DESIGN/DEVELOPMENT REVIEW COMMISSION
URBAN DESIGN REVIEW DISTRICT
EVALUATION SHEET
Case #2

ADDRESS: 911 Washington Street

NATURE OF REQUEST: Request for Certificate of Design Approval for new construction of a hotel.

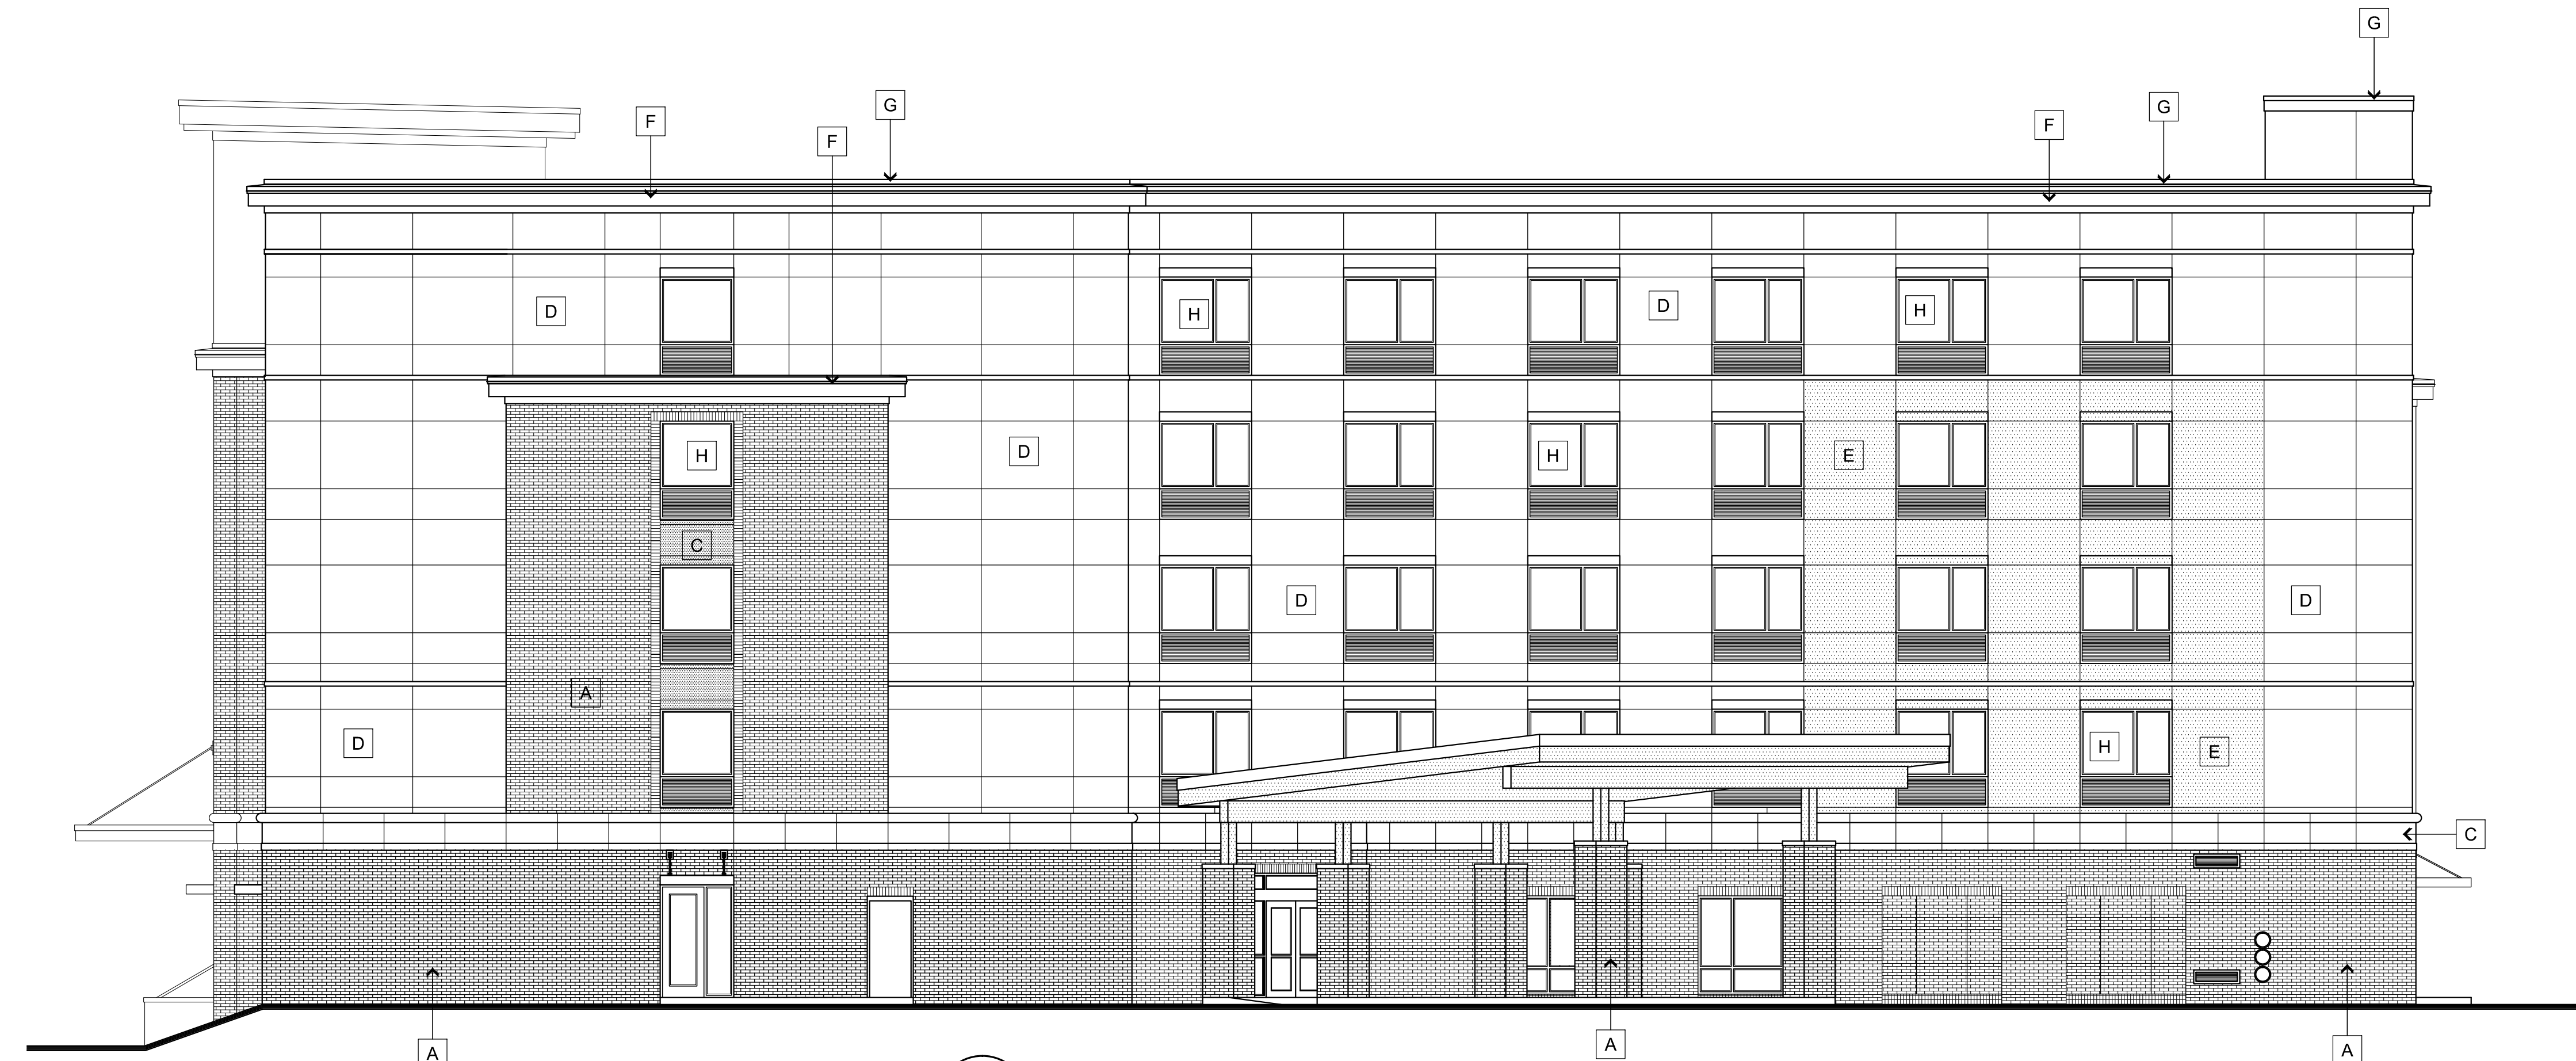
The Lincoln Street façade has some sections of blank wall along the first level, with what appears to be recessed brick panels. Depending on the programming inside (pantry and breakfast) spandrel glass might be a better solution to continue the pattern of openings.

The corner of the Lincoln Street façade is blank on the upper floors. This is a highly visible corner and needs more fenestration on the upper floors.

The first level of the building is a long flat wall with little articulation in the way of piers or other details. There are a couple of projecting bays but as noted previously, little relationship between the upper floors and the first level. As well, the first floor along Lincoln Street has some long stretches of blank brick wall. More thought should be given to how to better address this façade with the interior program of the building.

More articulation and fenestration should be added to the first floor along Lincoln Street.
